Urgent Field Safety Notice

With this letter we would like to inform you that the screw connection of the front wheel to the frame is faulty (screw loosening) and that corrective measures must be taken on the Mobilex arthritis rollator Tiger indoor models.

FSN (see attached delivery note with serial numbers).
Ref. FSCA: 01/2022

To all Users and Dealers of Mobilex arthritis rollator Tiger indoor

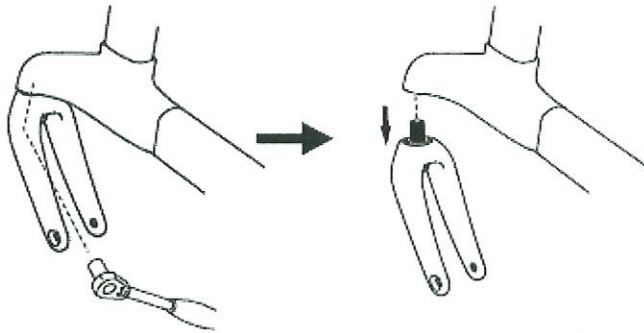
2.2.2. Unscrew the front wheel. Tools:

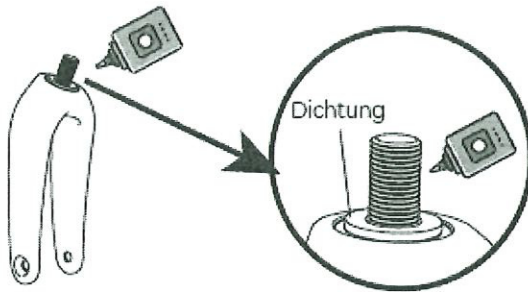
2.2.3. Loosen the M12 bolt and remove the front fork. Tool:

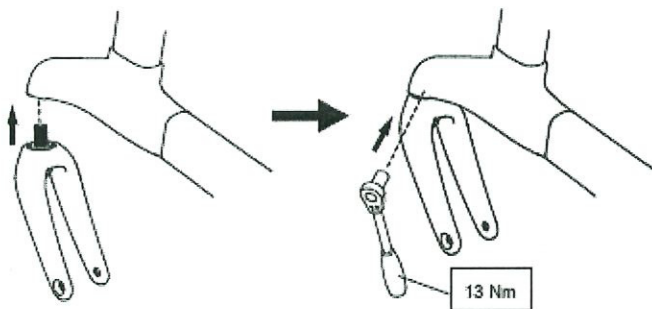
2.2.4. Apply glue to the thread only. Please ensure that the gasket remains on the screw for reassembly.

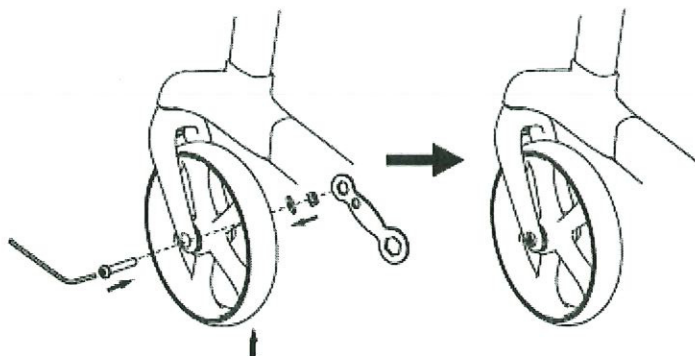
2.2.5 Reattach the front fork to the frame with the M12 bolt. Tighten the bolt with a torque of 13 Nm. Tool:

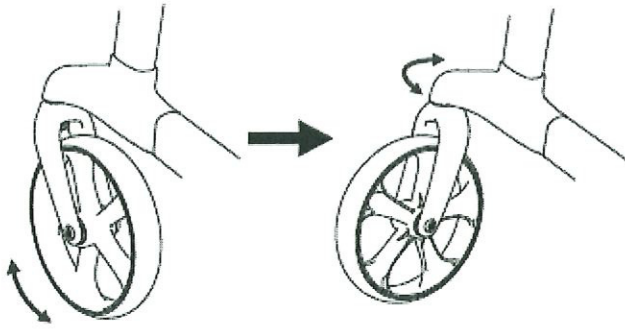
2.2.6. Screw the front wheel back on. Tools:
